PLAN OF PROPOSED IMPROVEMENT

HILL VALLEY - PHASE 1

CITY PROJECT NO. 15668
CONTRACT NO. 9643

REVISION 1 - 9/ 17/ 2025

15668
W-3

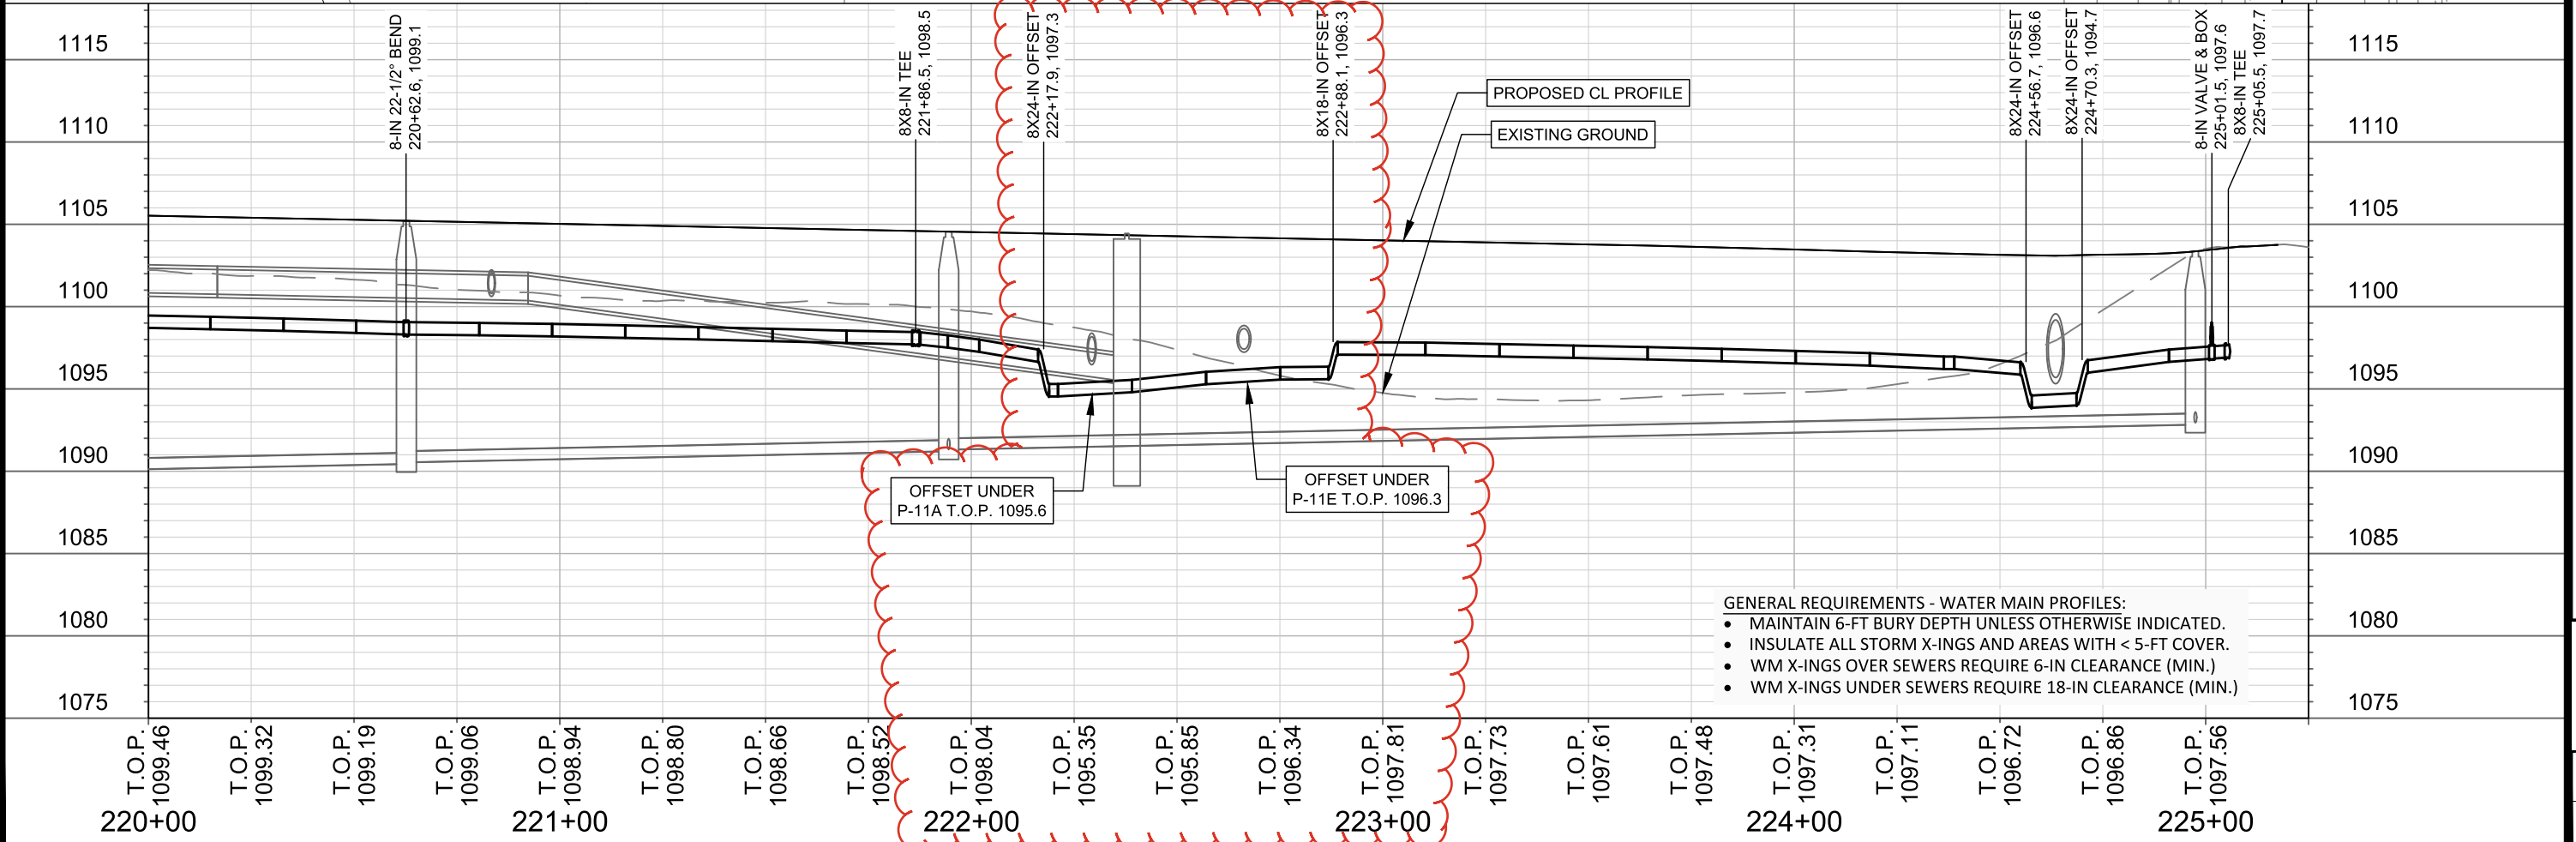
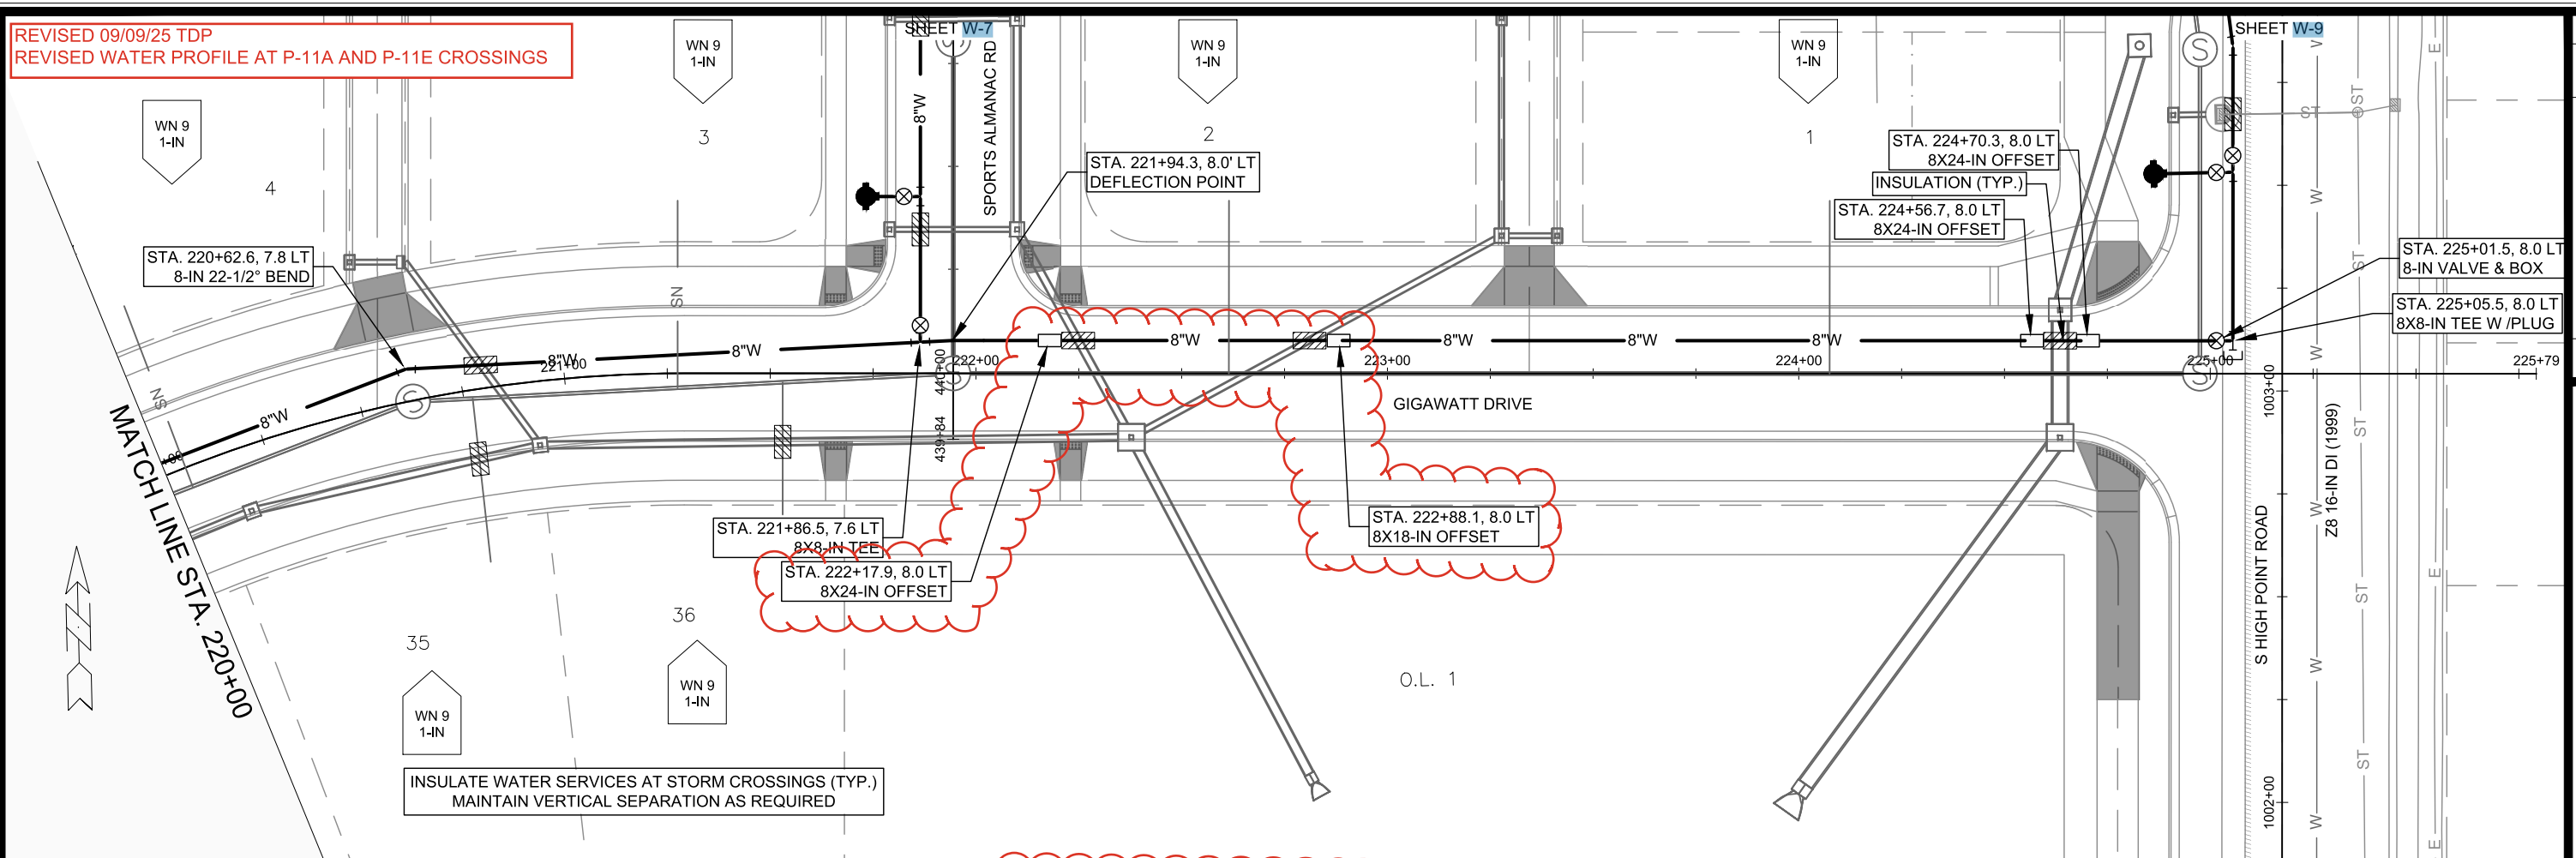
REVISED 09/09/25 TDP
REVISED WATER PROFILE AT P-11A AND P-11E CROSSINGS

15668		MADISON, WI		9643	
LANDSCAPING PLAN - WALDORF BLVD & OUT OF TIME LN		HILL VALLEY - PHASE 1		CONTRACT NO:	
REV1		PLANTING SITE IN FRONT OF OL 4 & 5		DATE	
MARK		REVISION		BY	
Designed By: FBEG		Date: 9/16/2025 8:16 AM		Scale: 1" = 40'	
15668		15668		L-3

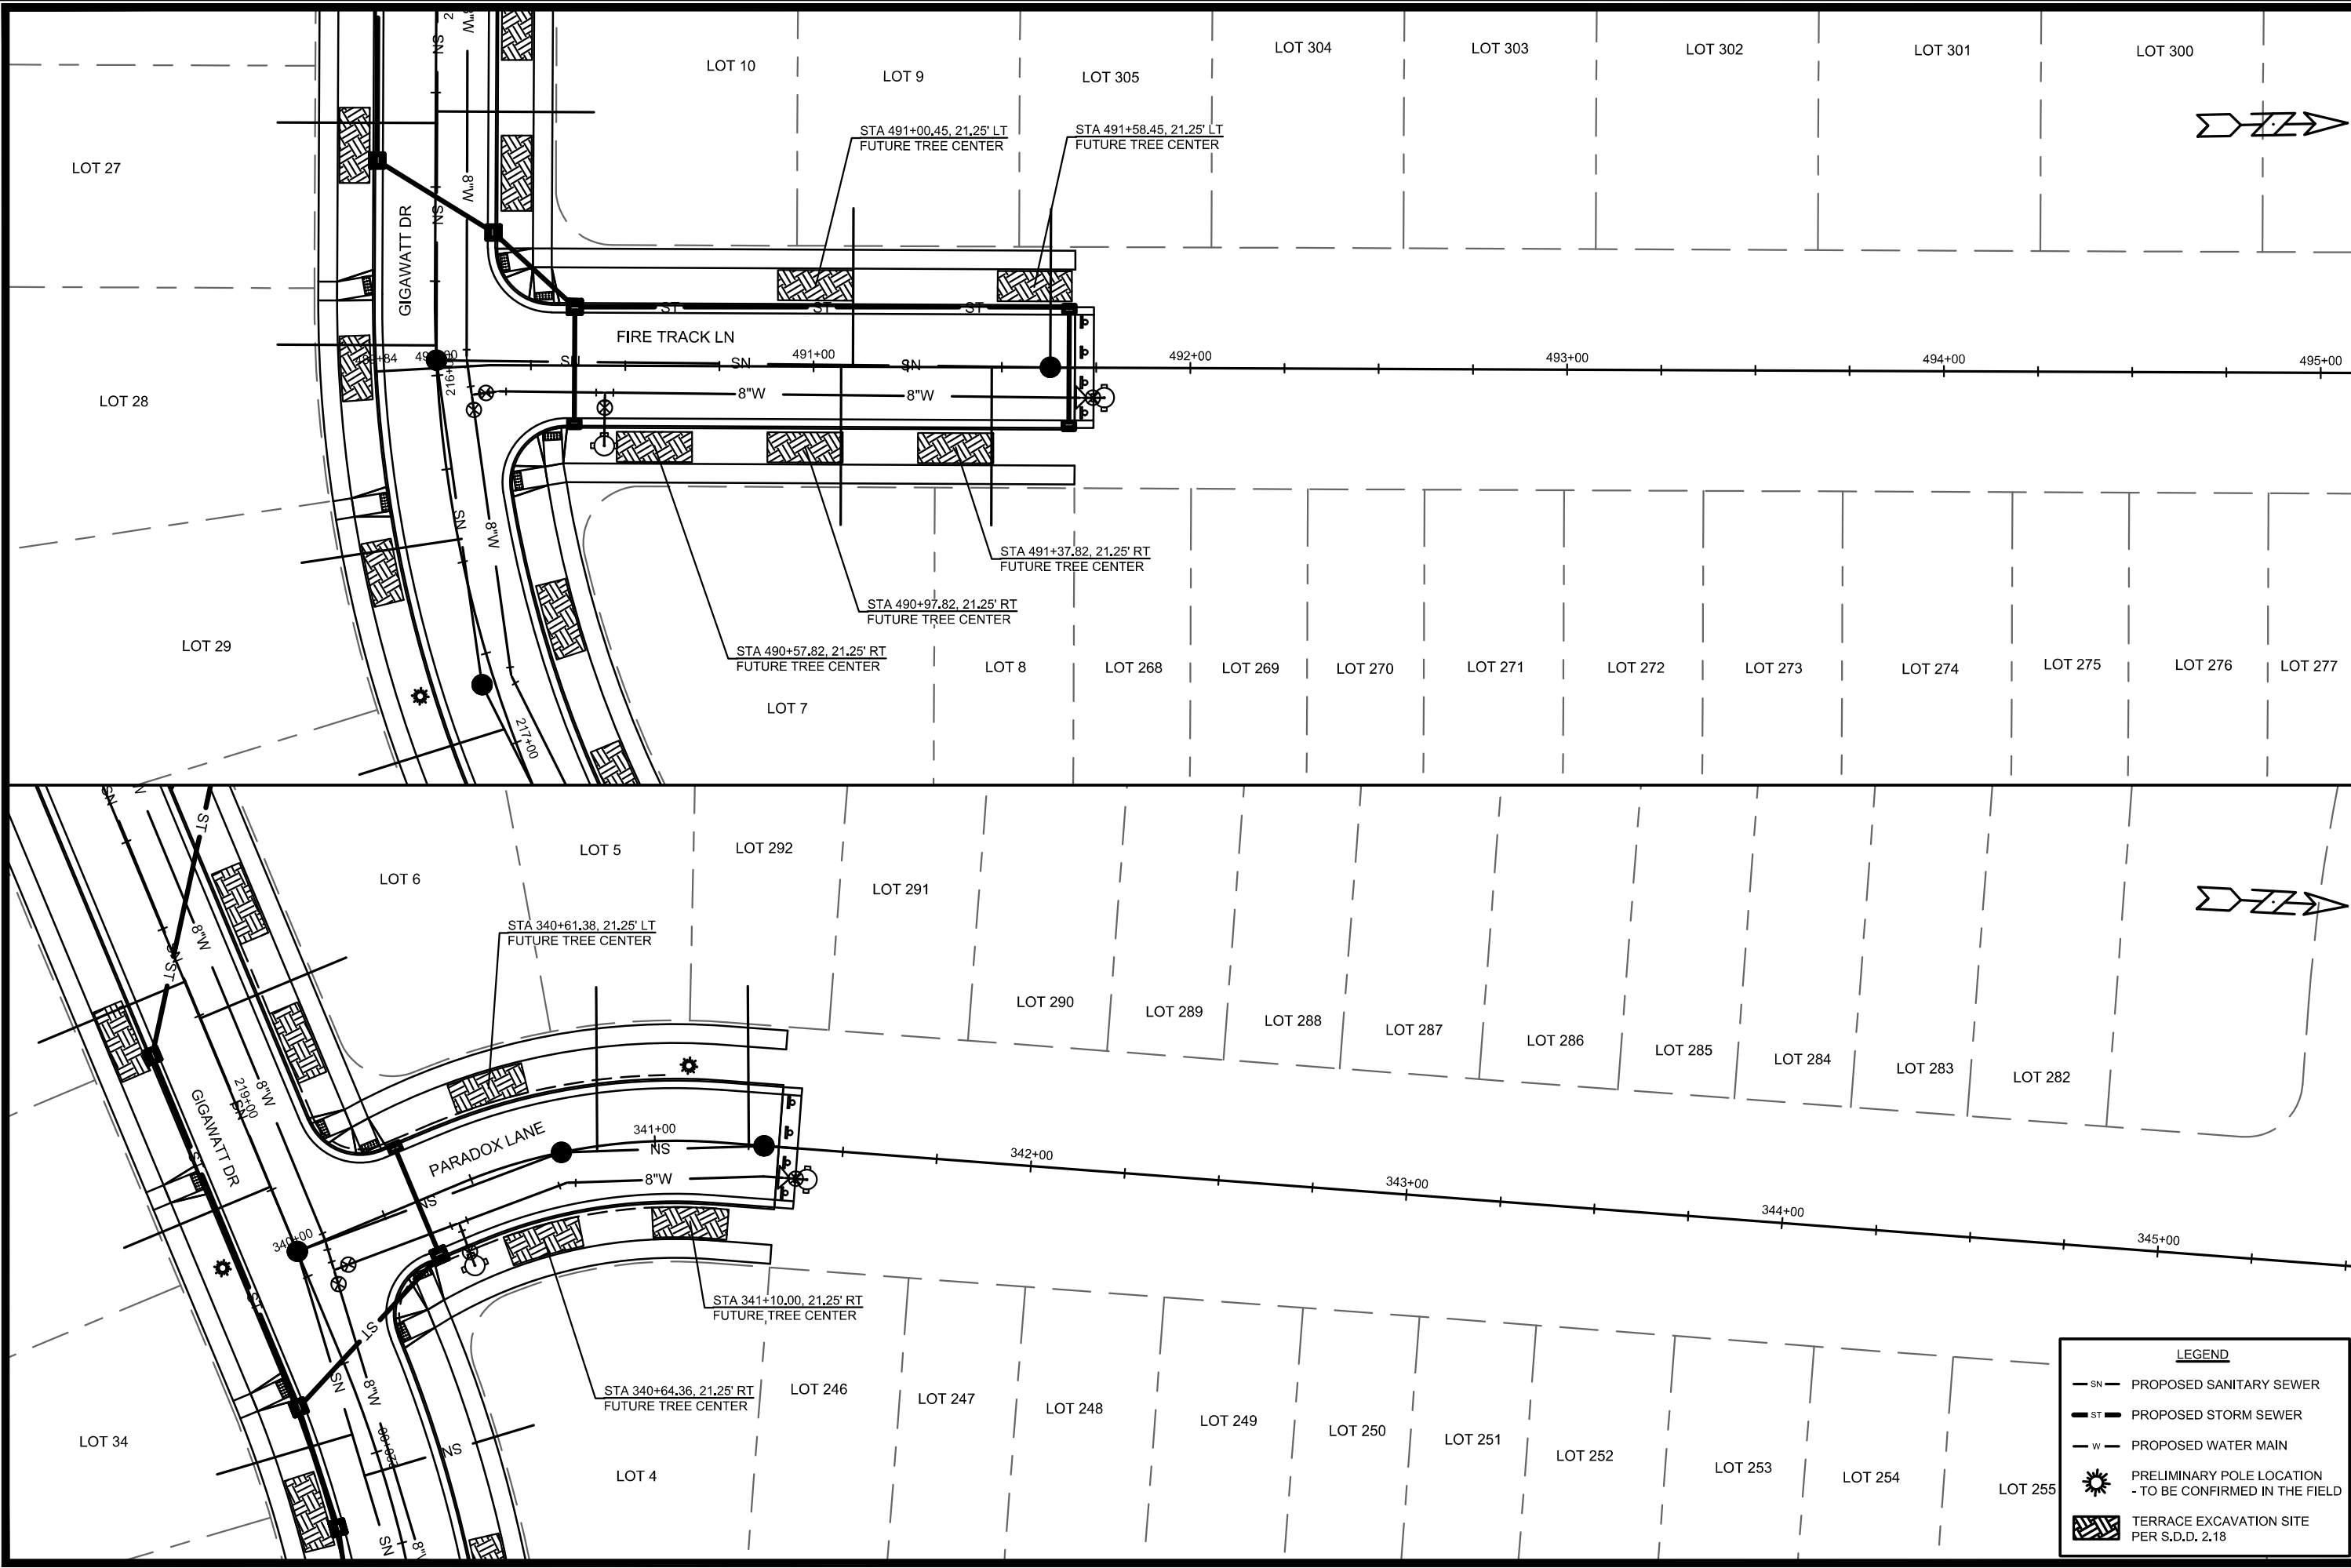
REVISION 1 - GCIT
PLANTING SITES ADDED
ALONG THE FRONTAGE
OF O.L.4 & O.L.5
